Service Bulletin

Bulletin No.: 18-NA-246

Subject: Malfunction Indicator Lamp (MIL) Illuminated - DTC P0172 Set (North America Vehicles Only)

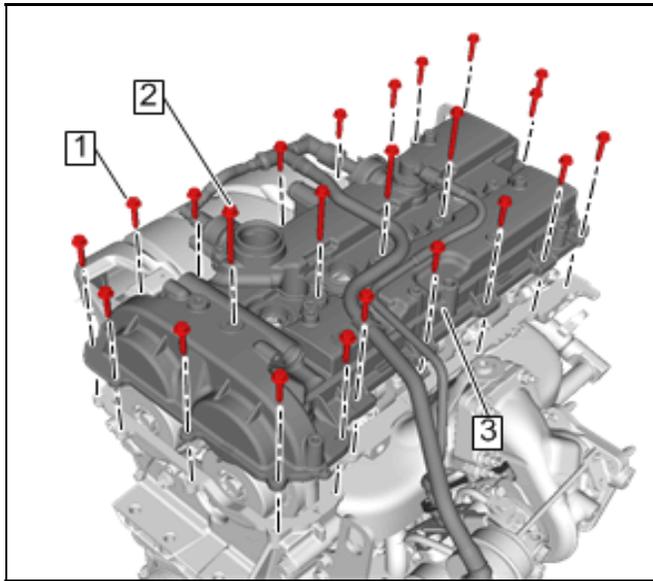
Note: The graphic above compares the old style primary PCV valve (A) to the **new** revised PCV valve (B).

1. Remove the camshaft cover (3). Refer to *Camshaft Cover Replacement* in SI.
2. Remove the old style PCV valve from the cover and **discard**.
3. Apply a light coating of oil to the **new** revised PCV valve O-ring.

4. Using hand pressure, install the **new** PCV valve into the cover until seated into bore.
5. Install the camshaft cover.
